## MEMORANDUM

To: Planning Board  
From: Lauren A. Wasilauski, Open Space & Stewardship Director  
Date: October 10, 2023  
Re: PB-07-23 The Malvern School Properties, LP  
Preliminary & Final Site Plan with Bulk Variances  
Block 28010 Lots 57 & 58  
982 Georgetown-Franklin Turnpike (Somerset County Route 518)

Figure 1: Screen grab of Montgomery Township GIS webmapper showing critical areas and associated buffer (in red crosshatching and solid pink/red) on subject lots.

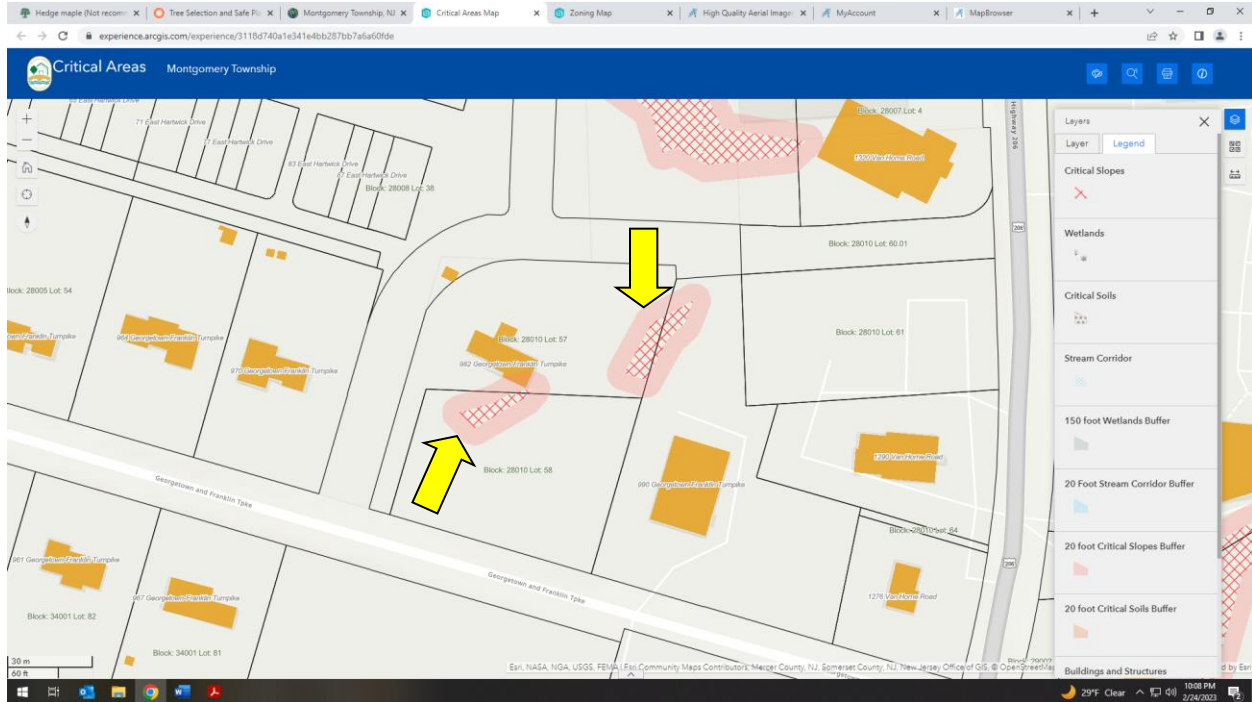
1. There are steep slopes on the property which the EIS report attributes to previous construction activities for the existing single-family dwelling (map on following page). Township Code Section 16-5.6e requires conservation easements or conservation easement deed restrictions on all critical areas. Because these steep slopes are not naturally occurring, this office does not recommend a conservation easement or deed restriction on these areas.
